Project Name: ORCHARD ROAD CHANNEL AND CULVERT IMPROVEMENTS
(RFP # 028-23)

CITY OF LUCAS, TEXAS
ORCHARD ROAD CHANNEL AND CULVERT IMPROVEMENTS
RFP # 028-23

ADDENDUM NO. 1

Bridge Division Standard	
<h2 style="margin: 0;">SINGLE BOX CULVERTS PRECAST</h2> <h3 style="margin: 0;">5'-0" SPAN</h3>			
<h2 style="margin: 0;">SCP-5</h2>			
FILE: scp05sts-20.dgn	DN: TxDOT	CK: TxDOT	DW: TxDOT
©TxDOT February 2020	CONT	SECT	JOB
REVISIONS			HIGHWAY
	DIST	COUNTY	SHEET NO.

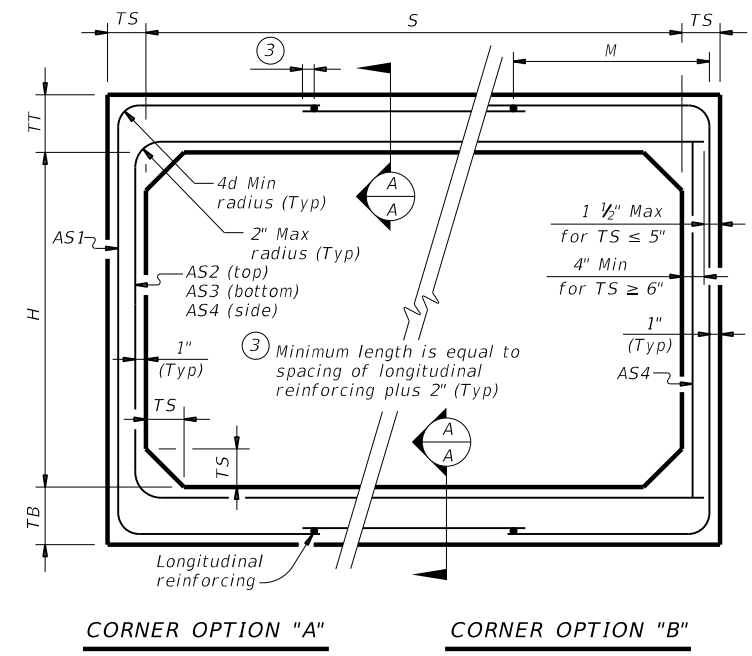
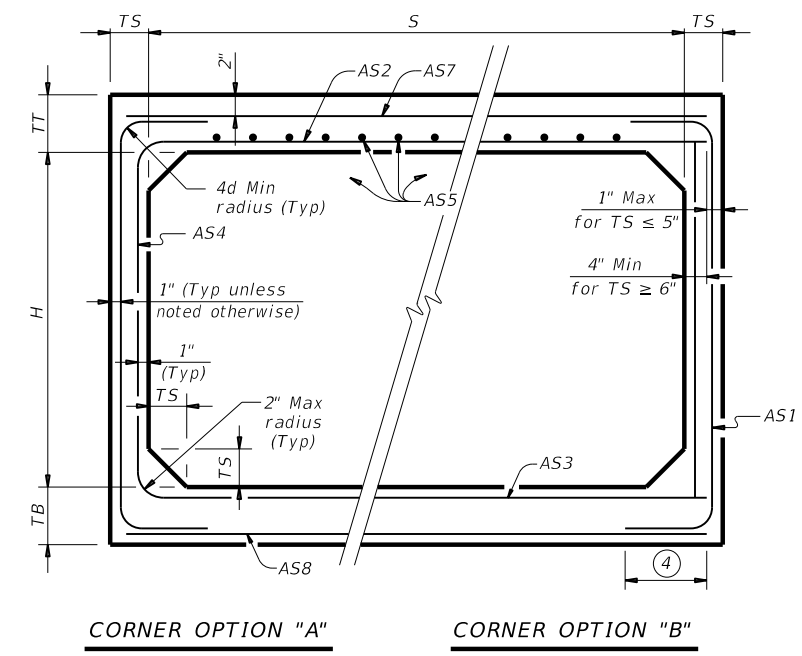
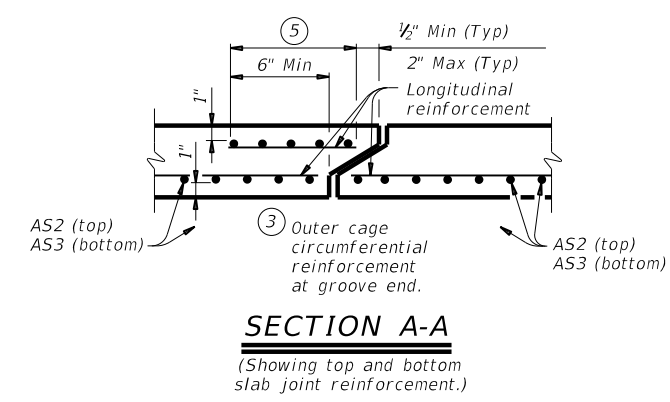
A. (Q) Can Precast Box Culverts be used for the crossing at Orchard Road?

(A) Yes, the City and Engineer do not take exception to using precast box culverts based on TxDOT Standard Details. The following TxDOT Standard Details related to Precast Boxes are issued with this addendum and are hereby made part of the plans and specifications for the Orchard Road Channel and Culvert Improvements project:

Bridge Division Standard	
BOX CULVERTS PRECAST MISCELLANEOUS DETAILS			
SCP-MD			
FILE: scpmdsts-20.dgn	DN: GAF	CK: LMW	DW: BWH/TxDOT
©TxDOT February 2020	CONT	SECT	JOB
REVISIONS			HIGHWAY
	DIST	COUNTY	SHEET NO.

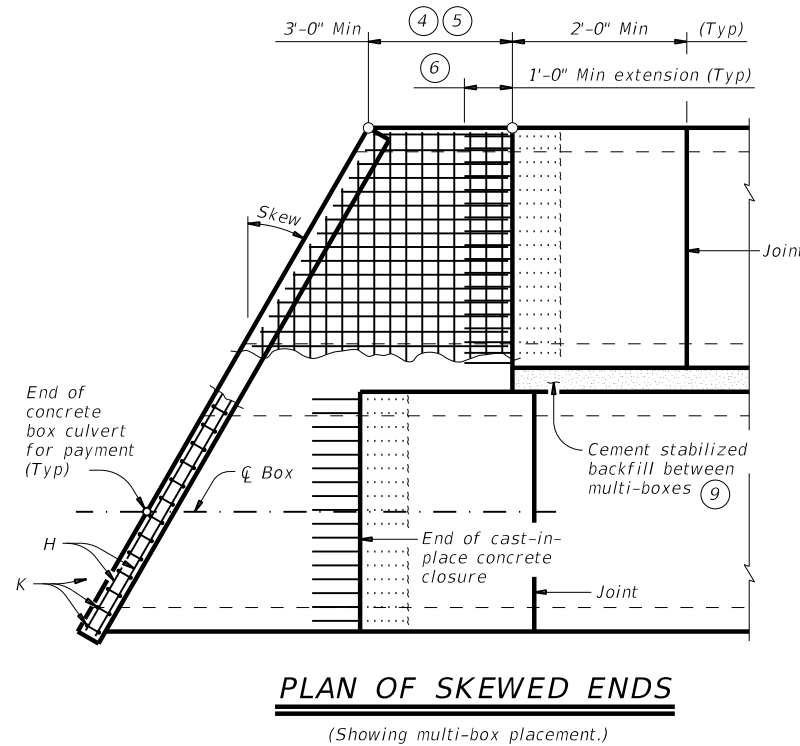
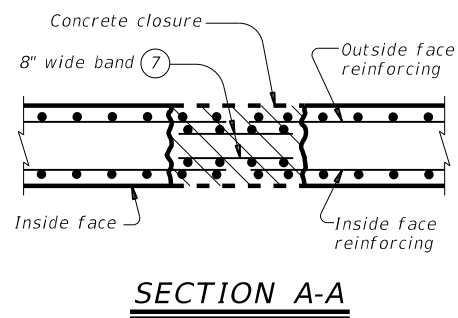
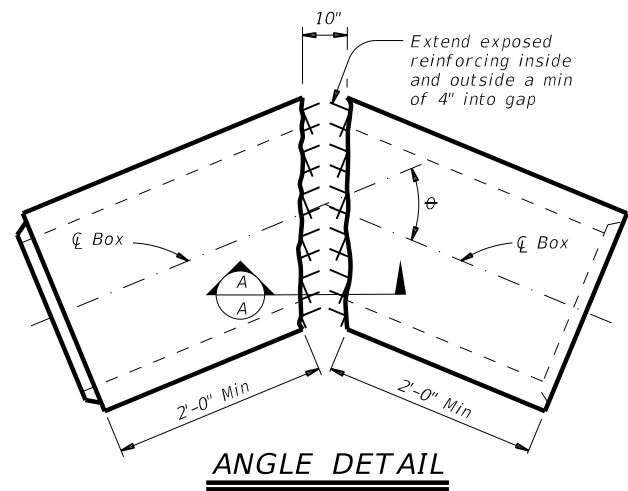
B. (Q) What is used between the boxes for precast boxes?

(A) Refer to TxDOT Standard SCP-MD – Miscellaneous Details. The details for treatment of the space between multiple boxes are shown at the top of this sheet.
